Probe for test of bias return line

Comments

Status & Summary

example : TEC_6_down (1666)

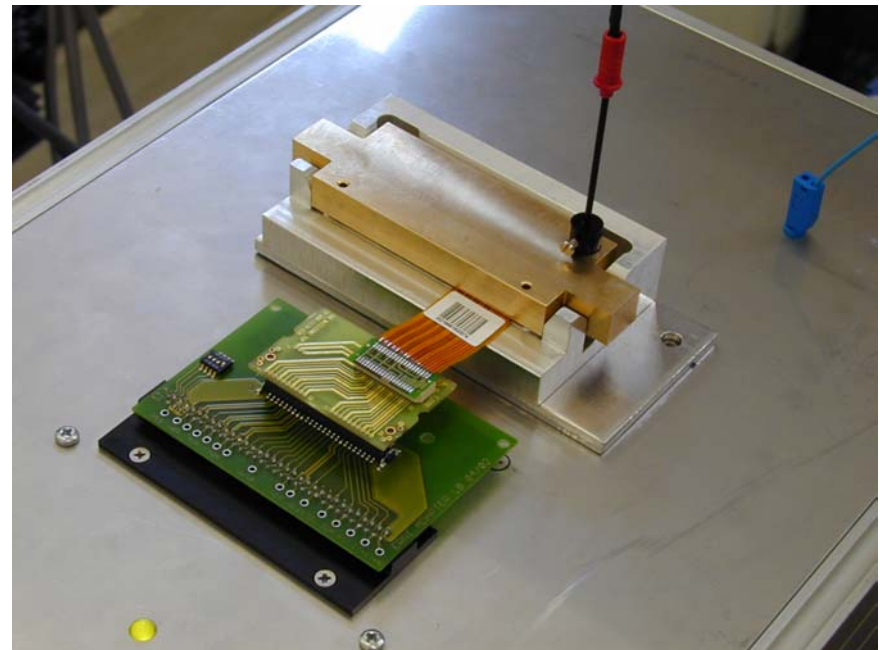
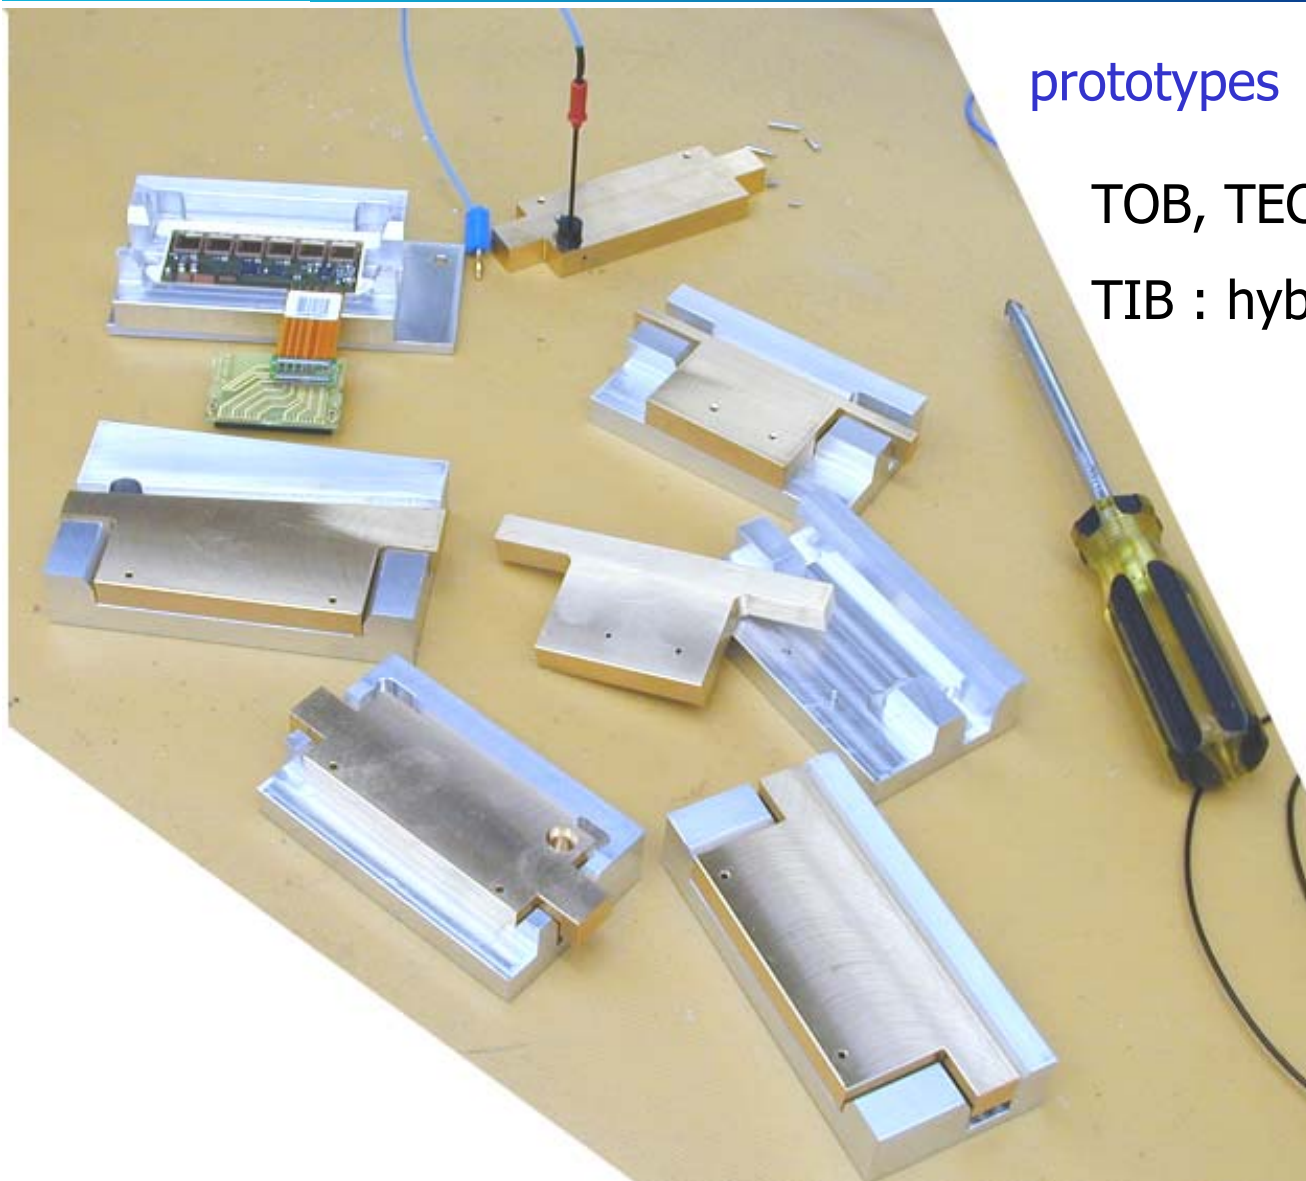
TIB : hybrid holes too small ?

The oblong hole should be on the left hand side
to improve accuracy

The dimension of the oblong hole is not the one specified (1.5 mm)
smaller than 1.45 for the TIB R-phi hybrid we have in hand
(ceramic we received were ok though)

The contact area for the continuity test of the det. return line is very small
possible alignment problem (related to the two above remarks)

→ probably difficult to change the mechanical layout

→ should be 1.5 mm to be checked with next TIB hybrids...

→ this cannot be changed
